11th March 2008

Re: Major Project, Nos. 1 to 5 Tweed Terrace, Tweed Heads – Duranbah Property P/L
- Addendum to Preferred Project Report

Amended Plans - Arkhefield

elevations north east

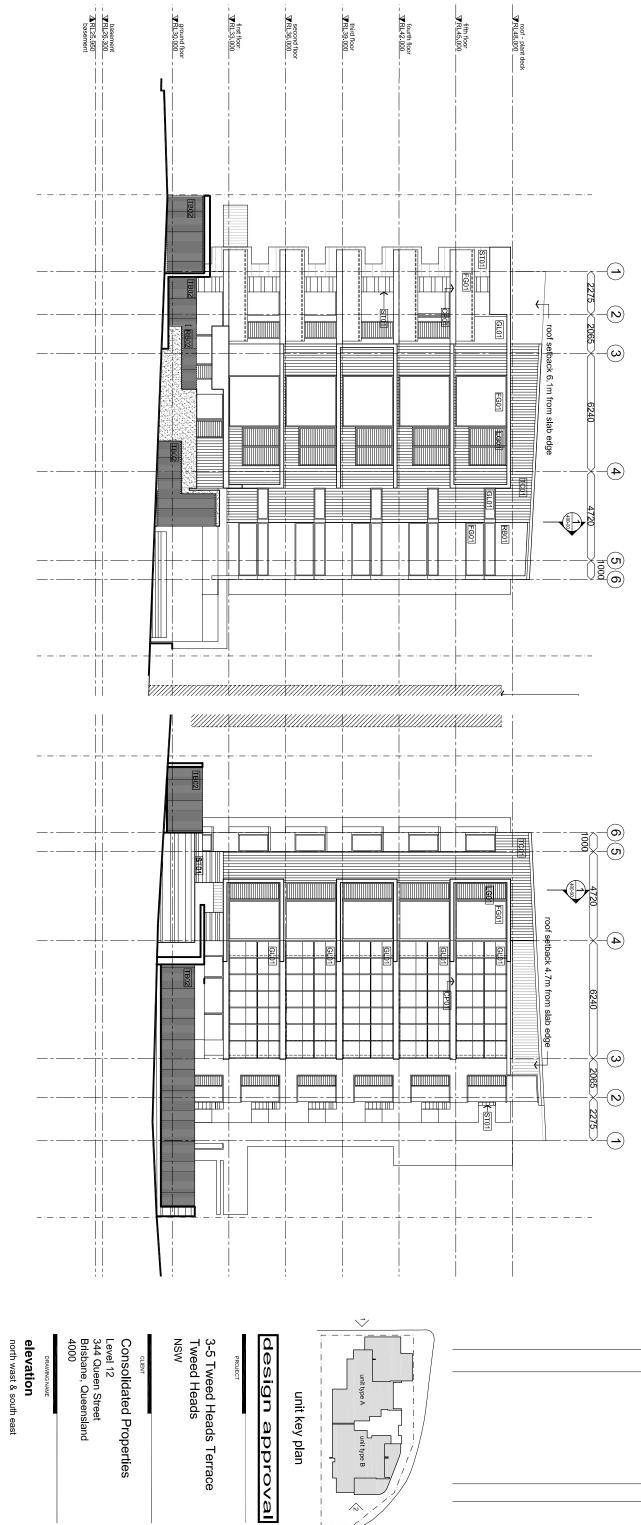
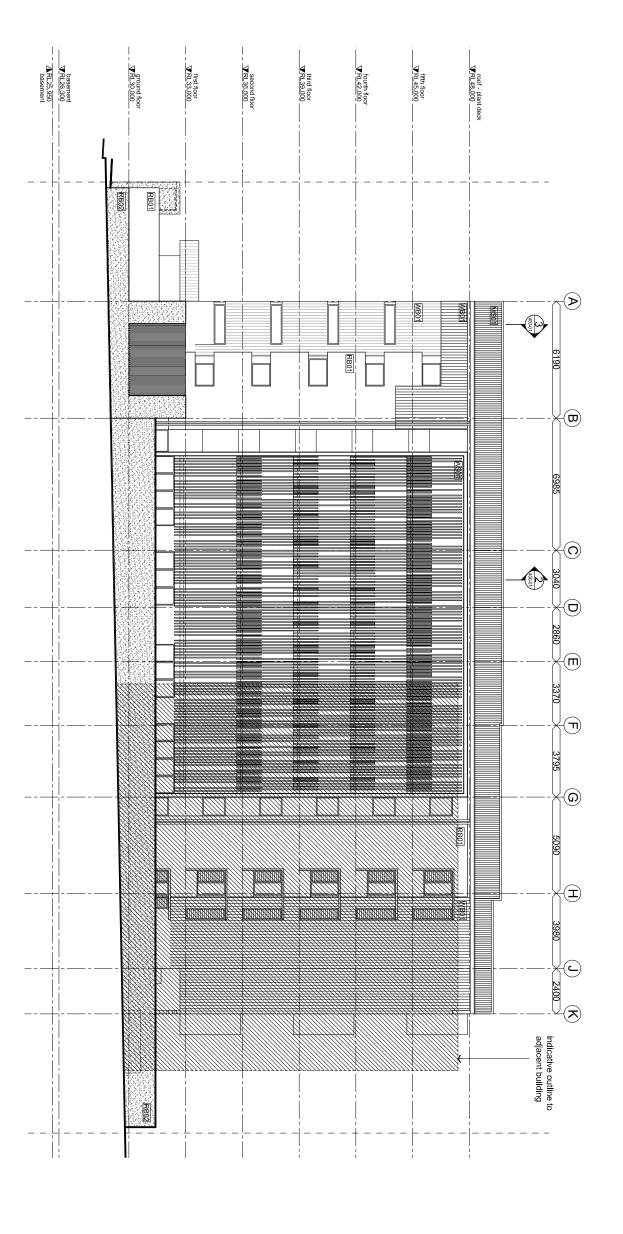
- 3. We have attached amended elevations and sections detailing the compliance now demonstrated with the building envelope as prescribed in Tweed Heads DCP. In this regard, the proposal continues to demonstrate compliance with the northern and southern elevations which are considered to be the greater barometer if you like, of impact on each of the view lines of the properties to the rear. The plans also depict a significantly greater level of compliance with respect to the western elevation, which now shows a continued encroachment at only the 2 upper levels and complete compliance where the building sits immediately adjacent to the primary balcony of the adjacent approved building to the rear. The latter area also results in substantial access to views as demonstrated in the attached plans prepared by Arkhefield. The upper level encroachments to the western elevation are considered to be acceptable on the grounds that the

4. By pushing the building forward to Tweed Terrace and redistributing mass across the site in order to gain greater separation to the rear, the proposal now incorporates greater non compliance with the envelope on the eastern elevations. The impacts of the latter have been offset by way of pulling the upper roofline back (so it is compliant), whilst also ensuring that the proposed encroachments are overwhelmingly open elements associated with the private open space balconies facing the east. Reference to the attached envelope diagrams confirms that the eastern elevation remains generally compliant in part, however encroachments remain relevant primarily at the upper level and associated with the central feature spine (vertical) in the central part of the building. Impacts associated with the now proposed minor non compliances with the eastern elevation are negligible to each of the adjacent properties (inclusive of that building located to the northern side of Boundary Lane), whilst also contributing little to a perception of excessive building mass give the recession of the upper roof line and the association of the encroachment to open elements only.

It is also important to note that masonry support columns have been removed from the eastern elevation where encroachment to the 3m line is proposed. These elements (particularly on the curve around Tweed Terrace to Hill Street) have been replaced by glass framing giving a greater lightweight form to the building and permitting greater view access (internal and external) leading to strong passive overlooking of the adjacent street. The latter has been largely facilitated through to the partial deletion of an ancillary deck off the southernmost unit's eastern elevation.

elevation

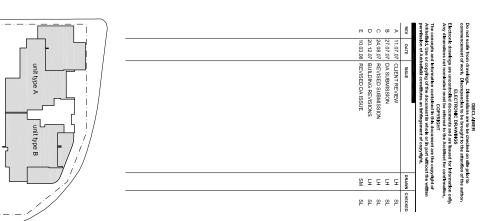
The proposal has in particular been amended through the deletion of a significant portion of the north western corner ensuite so as to increase the splayed view lines (to the east – Pacific Ocean) and physical separation from the property to the rear and also by way of shifting the building forward a minimum of 1m from the rear boundary, again in order to achieve greater separation between the rear building (as proposed) and subsequently greater compliance with the council's building envelope requirements.

- 5. The rear privacy screen has been amended to provide for a lightweight aluminium batten forms of varying thickness and lengths. This element ensures greater demonstration of manners to the approve development to the rear. This screen has also been bought forward and away from the common boundary to the rear.
- 6. We have discussed the issue of construction dewatering with Council's Environmental Health Unit and can appreciate where they are coming from. It is clear that the information submitted was not entirely deficient and that in fact only some additional supplementary detail was / is required in order to achieve greater consistency with council's desires. It is also clear that the Council is planning on taking these new requirements to the industry with the assistance of academic input in the near future. Our discussions with council's Senior EHO Officer resulted in agreeance to

section A-A

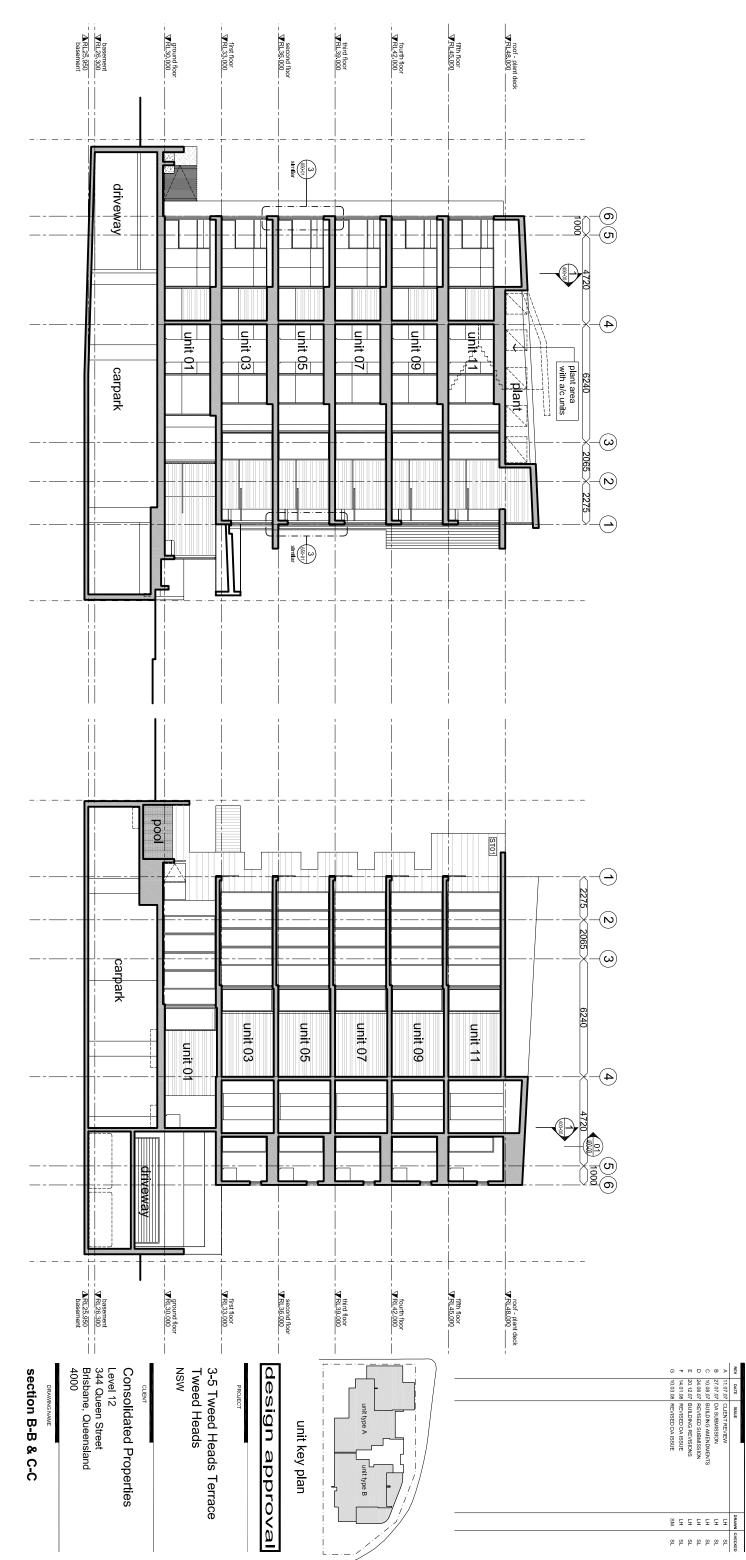
increased separation will ensure sufficient access to views, sunlight and breezes as referenced in the performance criteria underpinning the prescriptive envelope provision. In this regard it is noted that the adjacent (approved) building terraces away from the common boundary in accord with the slope of the site, whilst the adjacent proposal also demonstrates some non compliance at the upper levels. It is also important to note that the adjoining property to the rear was approved by Council (inclusive of upper level non compliances) with a separation between it and the recently constructed building to Hill Street of only 4.8m (balcony to balcony). In this instance, our clients have demonstrated an understanding of adjoining properties and exhibited good manners by way of addressing the importance of the adjacent open space areas by siting all balconies within our development to the opposite side of the building and by incorporating privacy screening in to the proposal as an architectural feature. The same can not be said of the adjacent (approved) building, which appears to have provided balconies to approximately 80% of the external facade as a means of almost 'moating' the development from future adjoining developments. Whilst the latter is fine in most circumstances, council canon only reasonably (given the expectation that adjoining sites would be developed in the short term) ensure that primary open space areas are protected and primarily those of a size consistent with the Tweed DCP. The amendments to the proposed development in fact go beyond simply protecting primary balconies, it goes further by ensuring adequate screening and privacy protection to adjacent properties (something neither of the adjacent developments appear to have done) and by preserving views, sunlight access and breeze access to the overwhelming majority of each primary private open space area.
